Sheet 10 today, and what goes wrong

Erbil plant - InteliNeo 5500 master - PLC sheet 10 "PV req step protection"

What I want to change

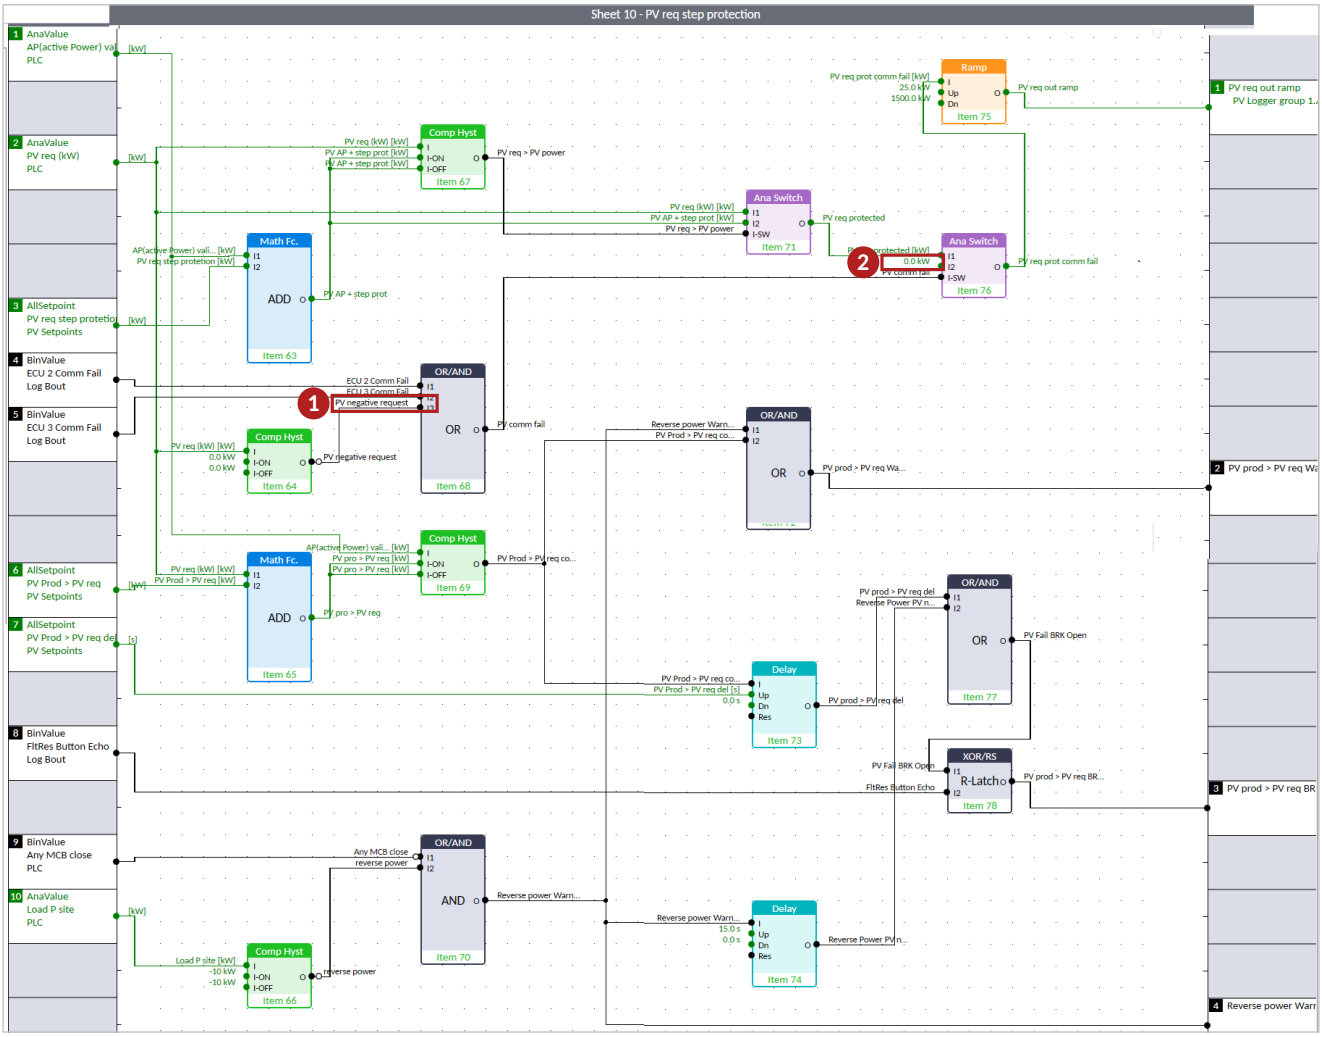
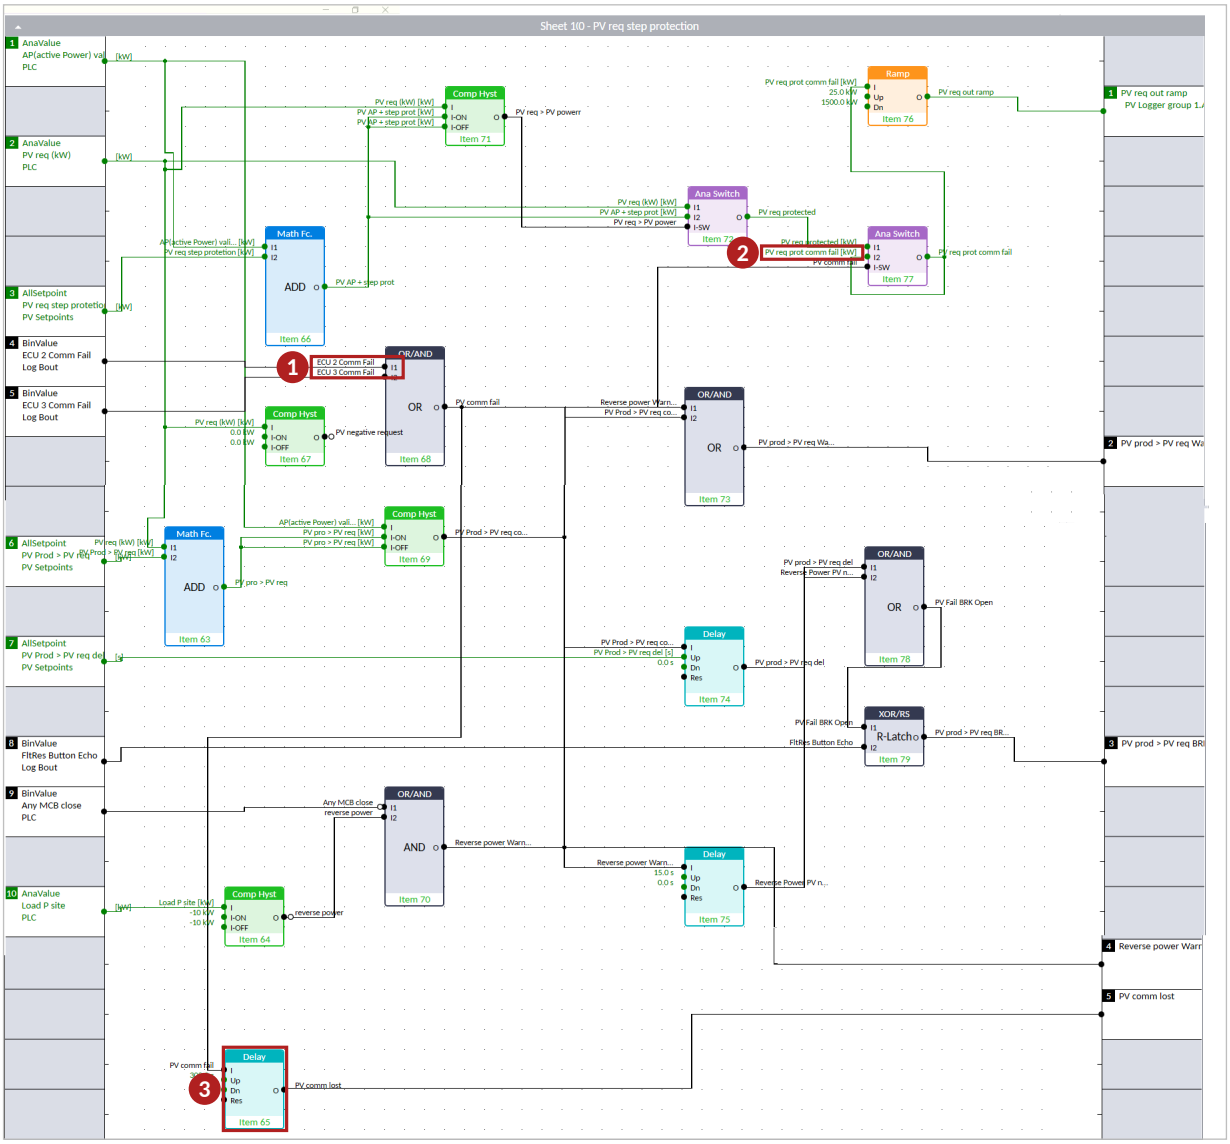
This sheet sends the solar plant its setpoint. Most of it is fine. The problem is one small switch, Item 76. Normally it just passes the request through. But if the controller misses even one reply from the PV logger, Item 68 (1) flips the switch, and the other side of the switch is a fixed 0.0 kW (2). So the solar plant gets told: zero.

The inverters do what they are told, within seconds. The gensets were running at 25 % and now they carry everything, in one step. Then the reply comes back, and the solar has to climb up again, 100 kW at a time, about five minutes. This happens five to thirty times a day. On 14 October, my last check, the history shows it 20 times between 08:52 and 09:58.

And here is the silly part: while the link is down, the zero never even reaches the logger. It arrives when the link is back, so it protects nothing. We just lose production every time.

Three small edits, nothing else. The switch (now Item 77) gets its own output on its second input (2). So when a reply is missed, it just keeps sending the last setpoint. Nothing drops, nobody notices. Item 68 (1) now only listens to the two real comm fail signals, so if the controller really wants zero, zero still goes out. And one new timer, Item 65 (3), raises a flag called PV comm lost if the logger stays silent for five minutes. For now that flag only goes to an alarm.

With a healthy link, the program does exactly what it does today. I ran the whole program block by block against our own history to check that. While the link is down, nothing is different from today either: the inverters keep their last setpoint in both versions, the gensets have 25 % in hand, the controller's own protections still work without the logger, and after five minutes we get the flag. If anyone wants it back, we load the archive from 14 October. One minute.

On the day of 14 October this change would have given us about 350 kWh more solar and spared the gensets three of their load jumps. And it is the first step before we can run fewer gensets, which is where the real fuel saving is.
